Technical Service Bulletin: TSB210206

Steel Lubricating Oil Pan Adapter Cover Cracks: Lubricating Oil Leaks

Figure 3, Comparison of Lubricating Oil Pan Adapter Cover. Left: Steel, Right: Aluminum.

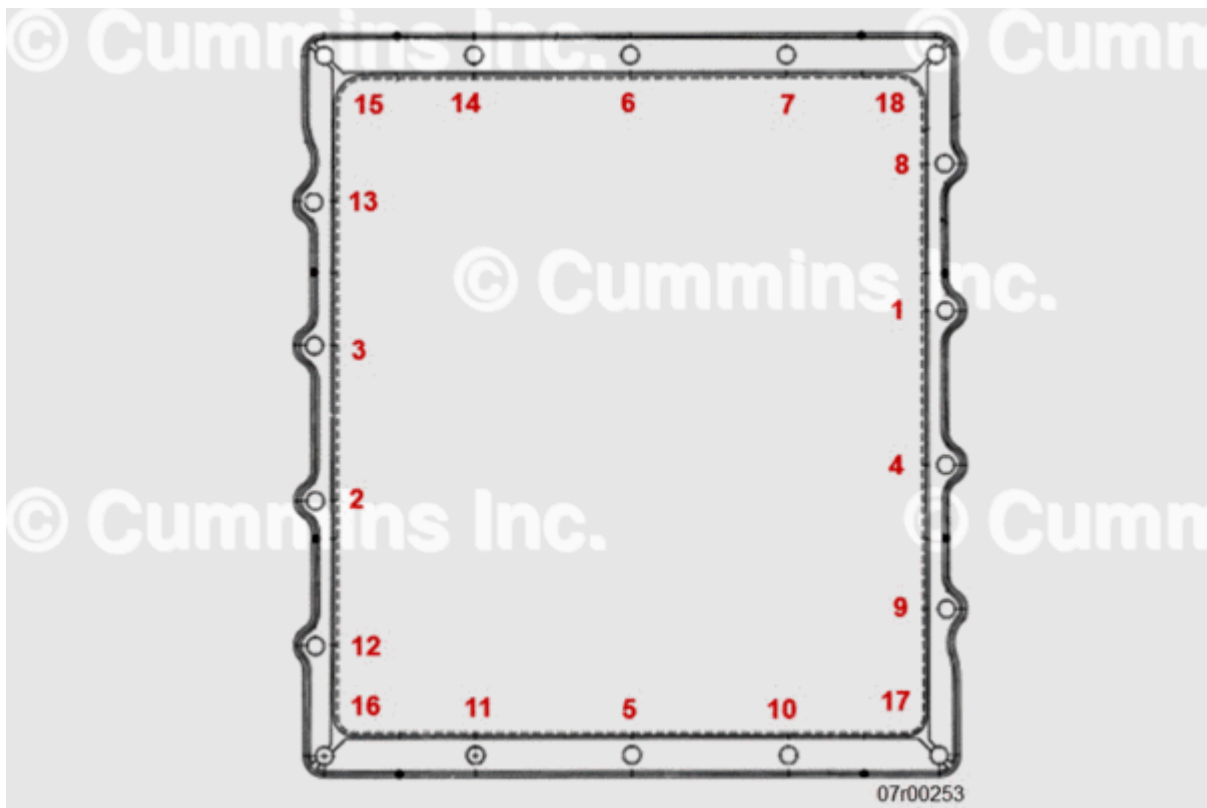
- If the steel lubricating oil pan adapter cover, Part Number 3070780, is cracked; replace lubricating oil pan adapter cover with aluminum lubricating oil pan adapter cover, Part

Number 207306.

- See Figure 3 below for a side by side comparison of each type of lubricating oil pan adapter cover.
- When using aluminum lubricating oil pan adapter cover, Part Number 207306, install the following:
 - New gasket, Part Number 3073213
 - Quantity 18 of new capscrew, Part Number 3035624. Torque to 47 N•m [35 lb-ft] using torque sequence in Figure 4 below
 - Quantity 1 of washer, Part Number 67946
 - Quantity 1 of threaded plug, Part Number 3055069. Torque to 54 N•m [40 lb-ft]
